Aspen Business Park

Response to Pre-Application/ Other
Review Comments

Re: Aspen Business Park Master Plan
Application Number: DA-2304-00
Case Number: 2022-7001-00

PIP-2

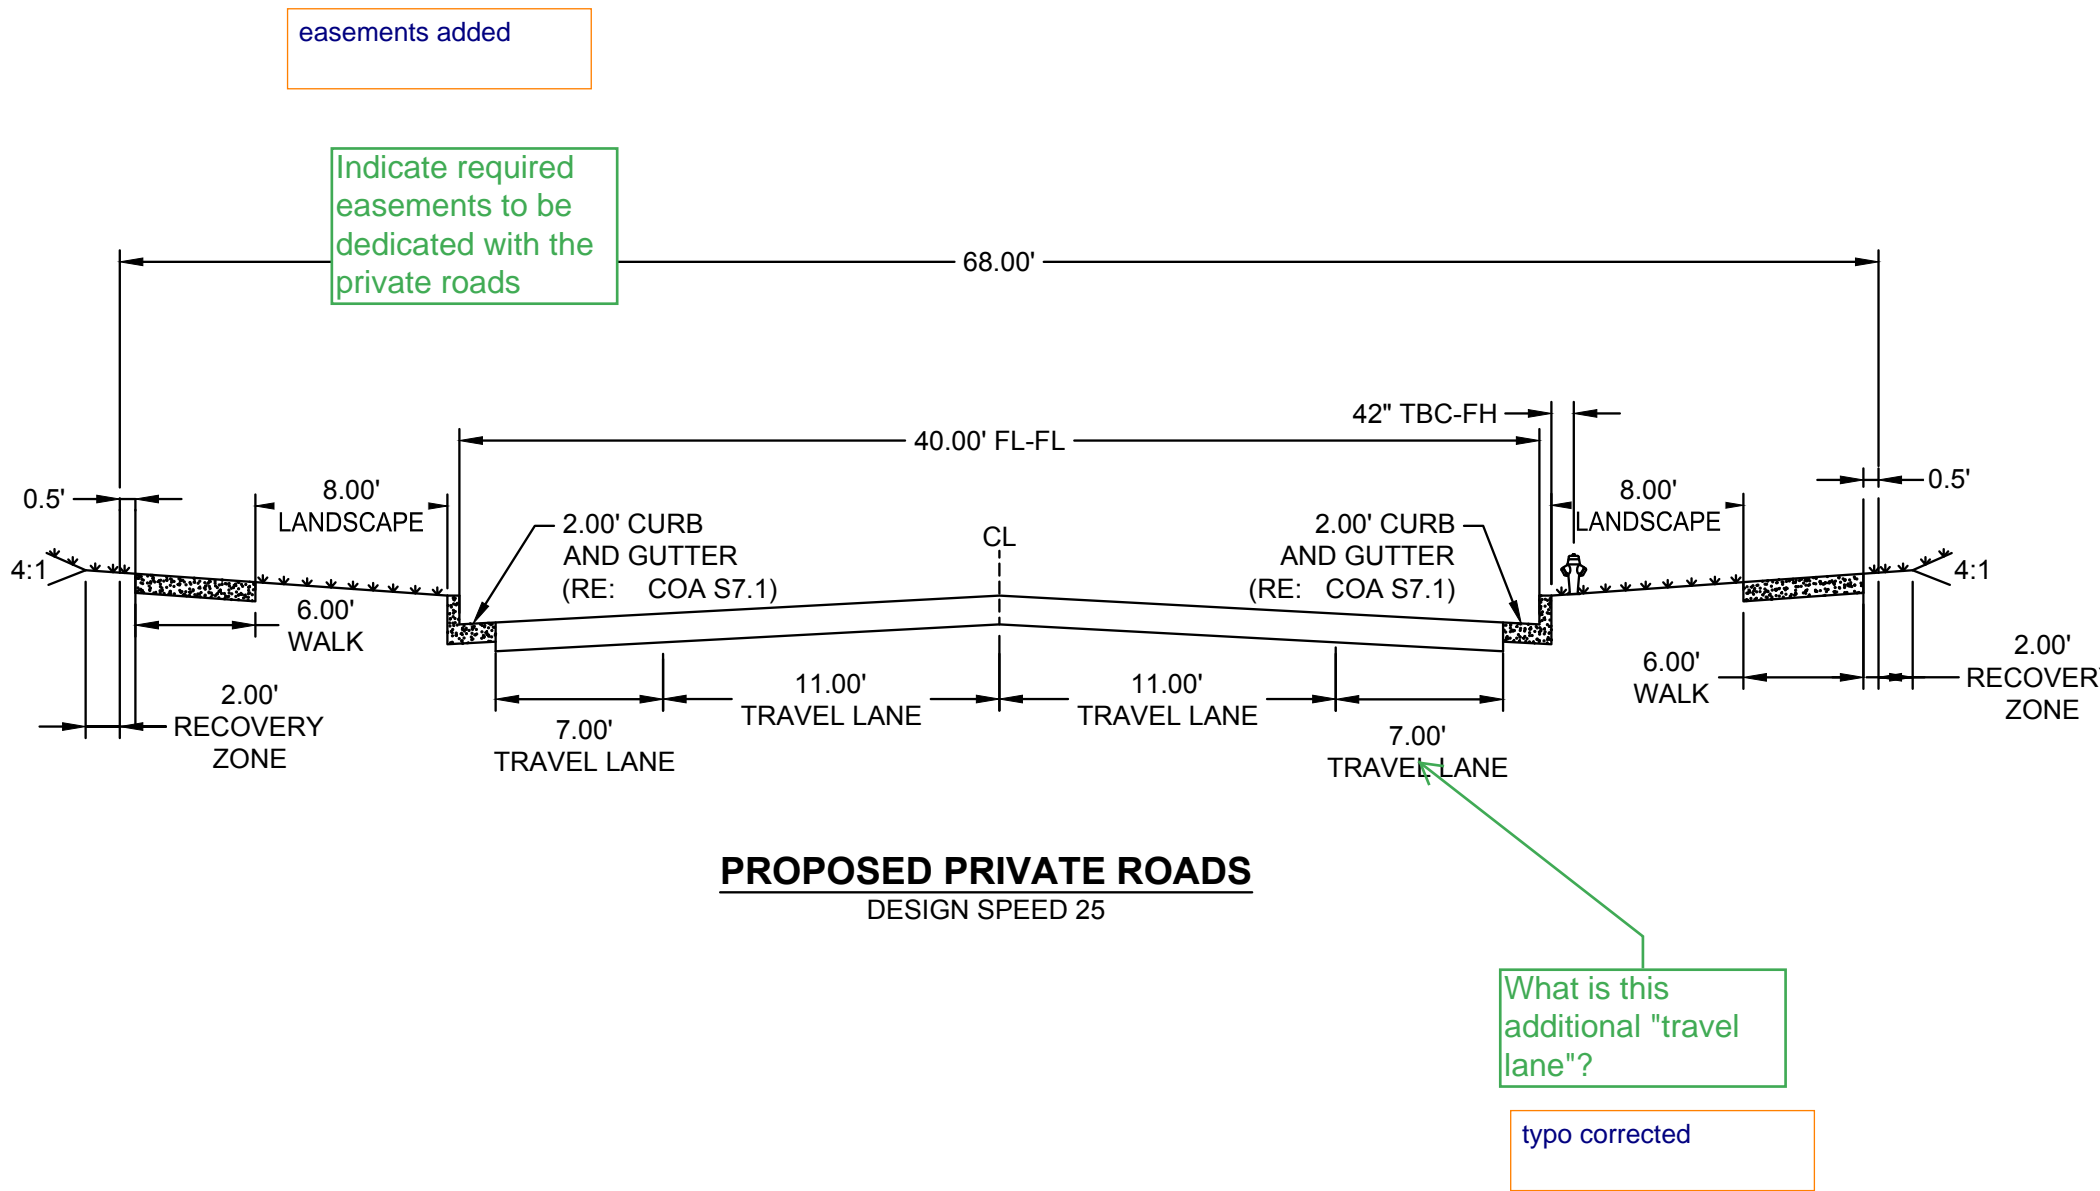
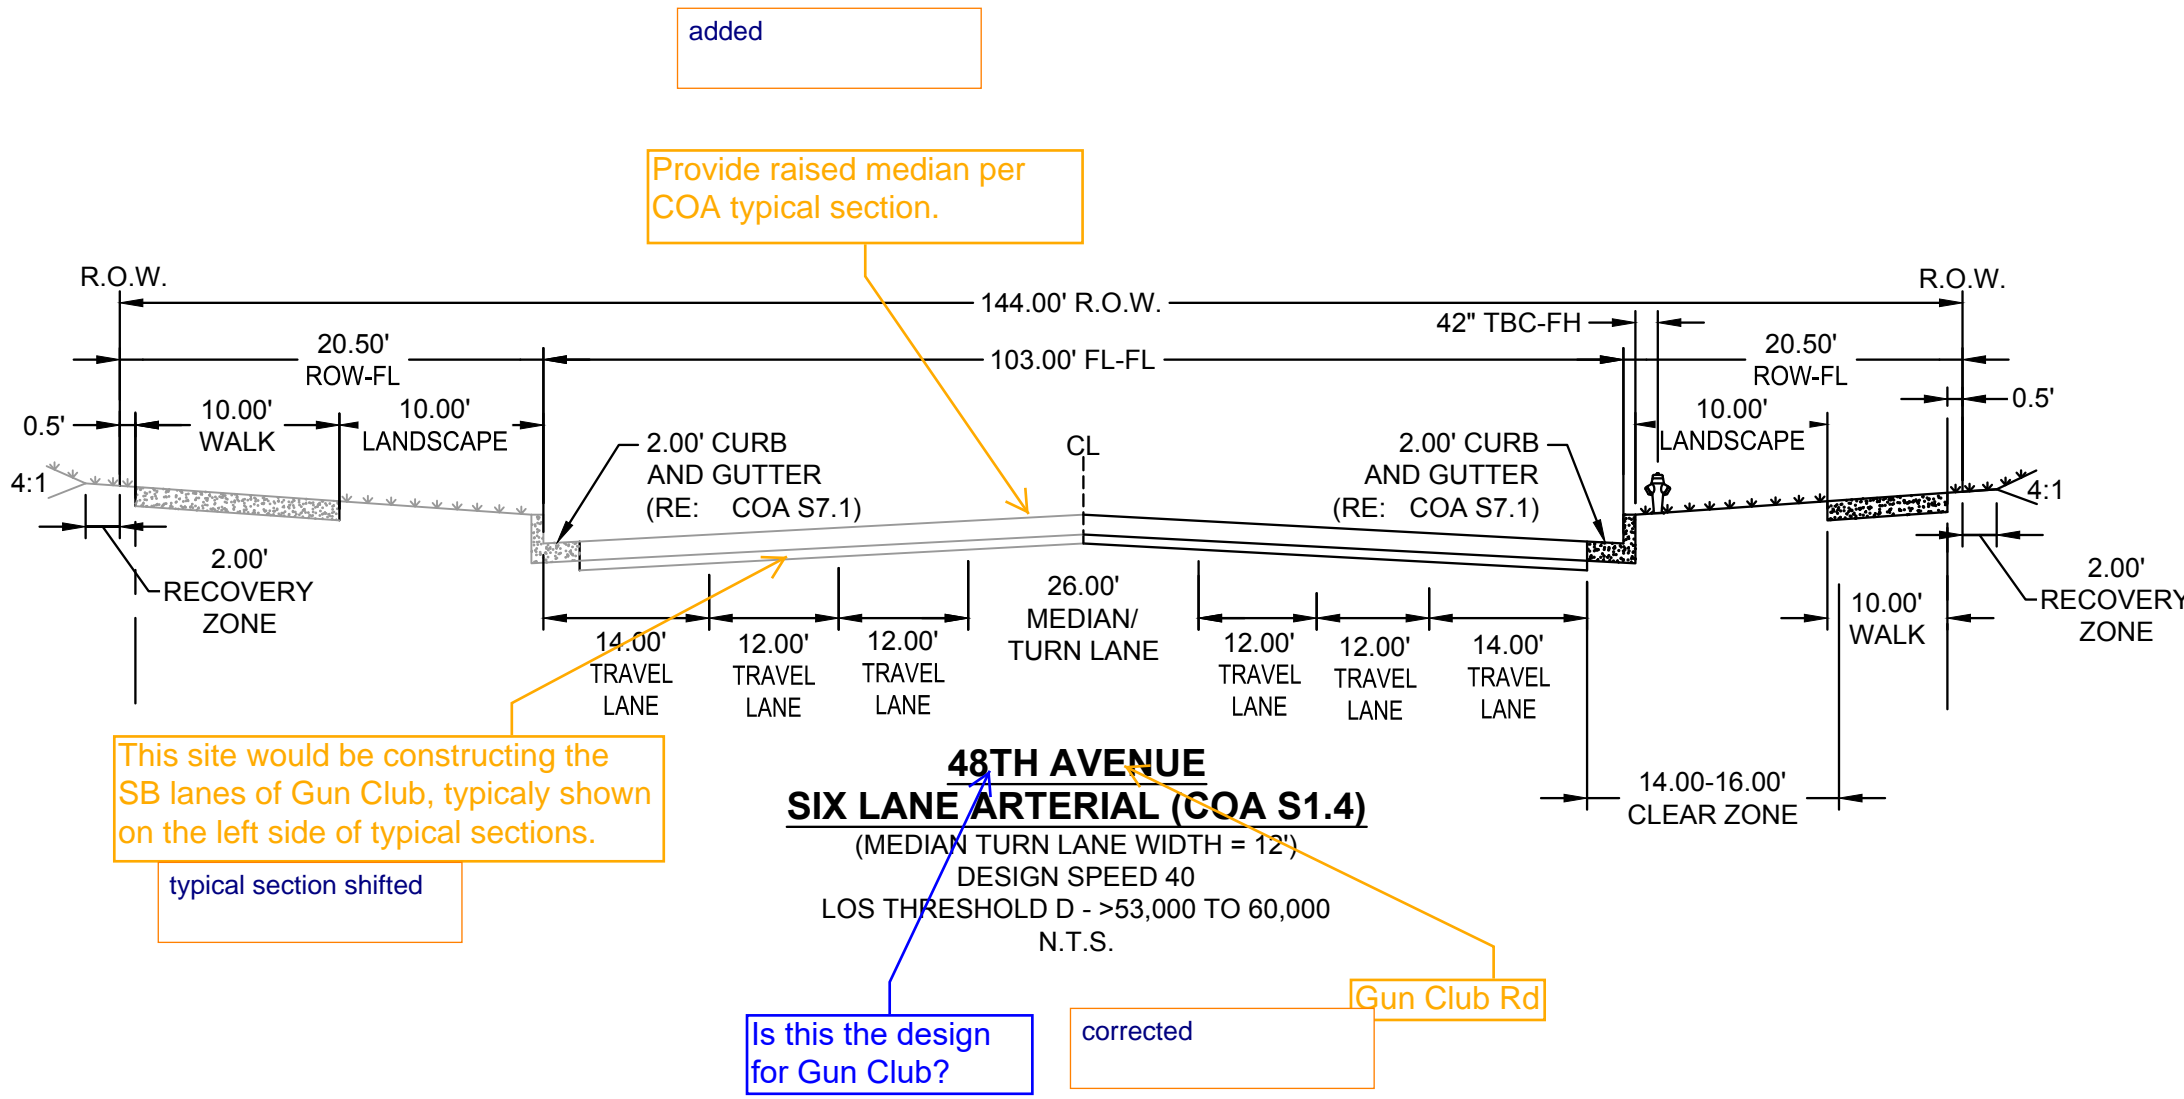
6F. *Show required easements to be dedicated with private roads with the section on Sheet PIP-2.*

6G. *What is the "additional travel lane" shown on the Proposed Private Road Section?*

added

SHEET
C1

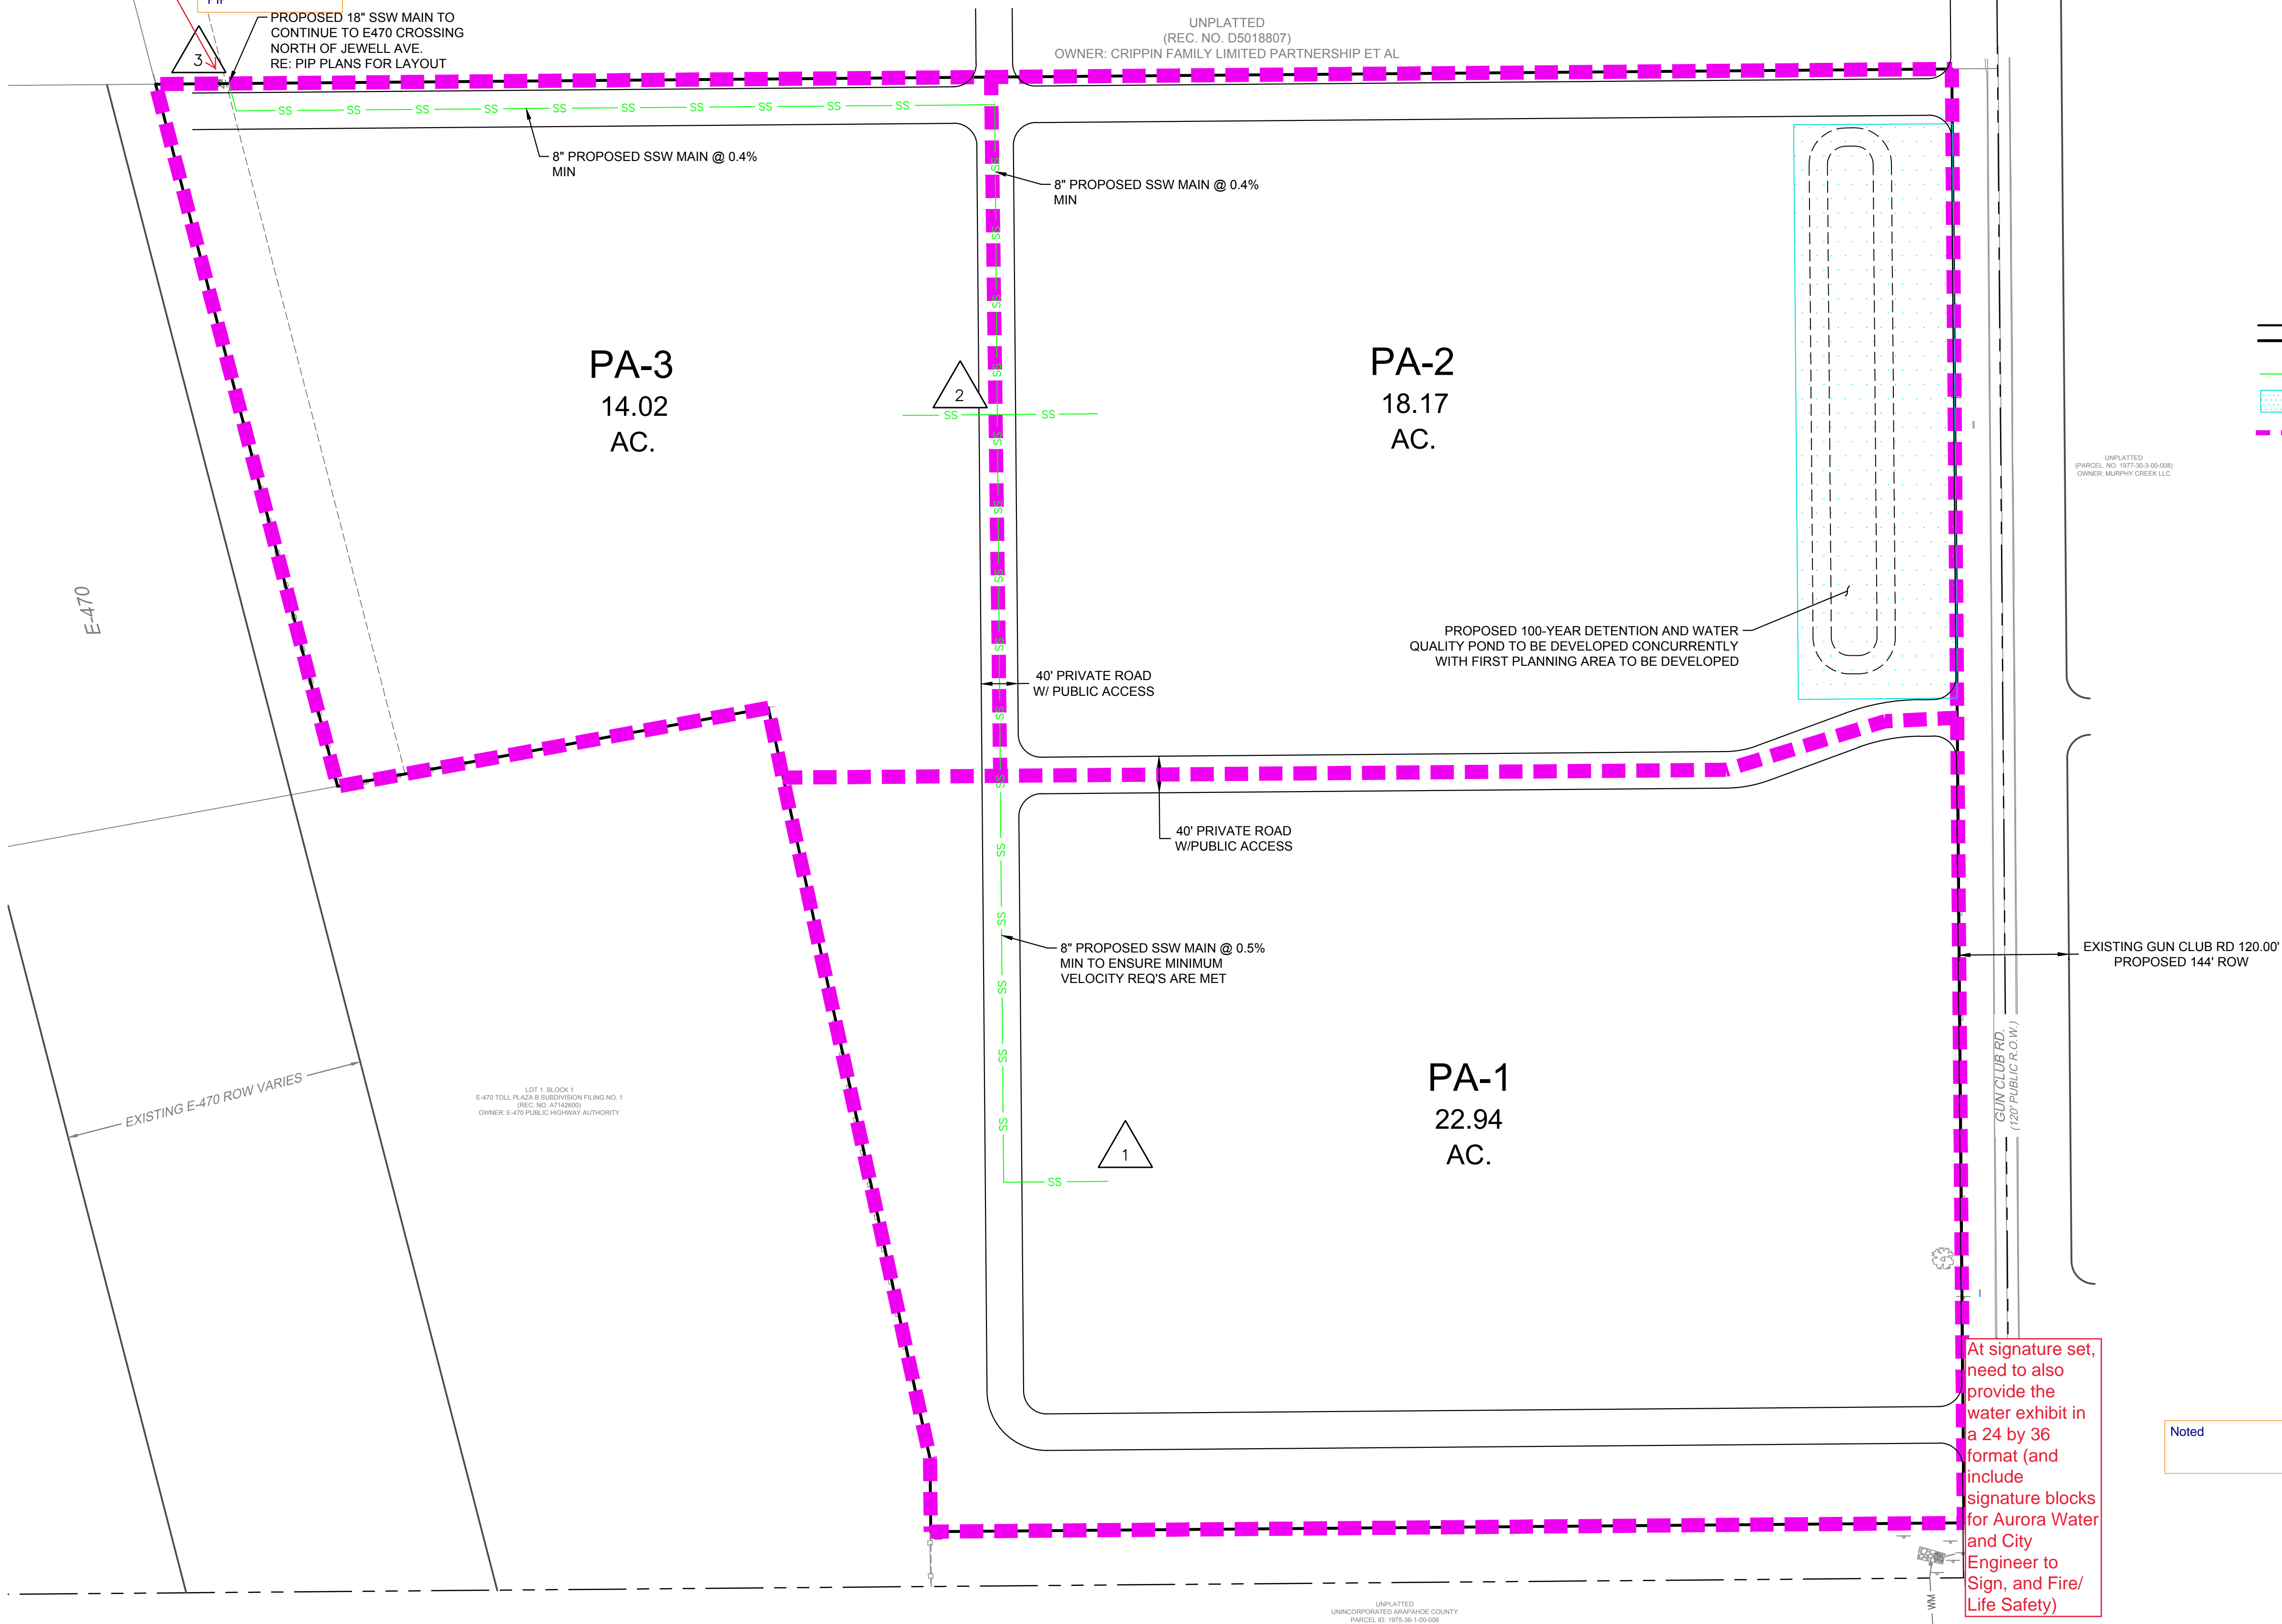
Expand on this to show the connection

Include a key map

Include a note on all exhibits that this site is for industrial - typ.

an exhibit was previously included in this report to show the extents of this connection but was reviewed to be inappropriate because it was an exhibit that was also included in the PIP. The title of this exhibit has been revised to not include "pip"

Key map added

Note added
